FAI-CR55-3.319 HOC-21 HAMBURG ROAD BRIDGE REPLACEMENT PROJECT ADDENDUM #2

February 26, 2026

ADDENDUM #2

STRUCTURE GENERAL NOTES - 1
BRIDGE NO. FAI-C0055-0332
OVER MUDDY PRAIRIE RUN

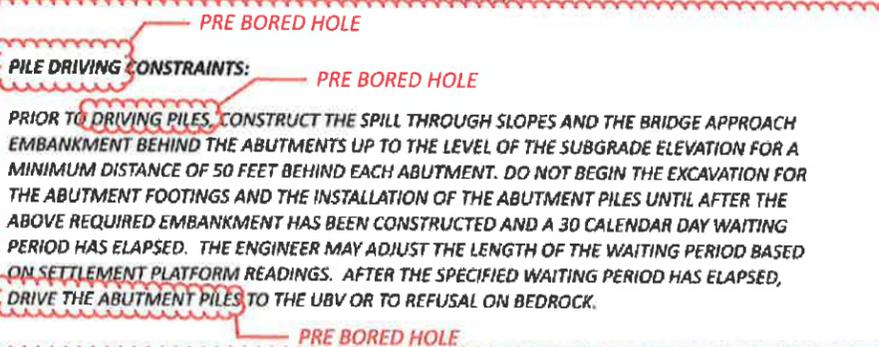
1. Replace sheets 1, and 36, of the plans with the attached. The pile driving constraint notes have been revised.
2. Construction dates have been revised to "may not commence prior to May 3, 2027, and must be completed no later than October 1, 2027, with work to be completed within a sixteen (16) consecutive week period." Please replace the following pages of the bid packet: Page 3, 6.1, 7.1, and 8.1.
3. The bid opening date has now been postponed until March 16, 2026. Please replace the following pages of the bid packet. Cover page, page, 3, page 4.1.

ADDENDUMS			
NO.	DESCRIPTION	DATE	APPROVED
1	ITEM 505 PAY ITEM REMOVED ON P.6 AND ESTIMATED QUANTITIES P.38	02/25/2026	WGM
2	REVISED PILE DRIVING CONSTRAINTS NOTE ON P.36	02/26/2026	WGM
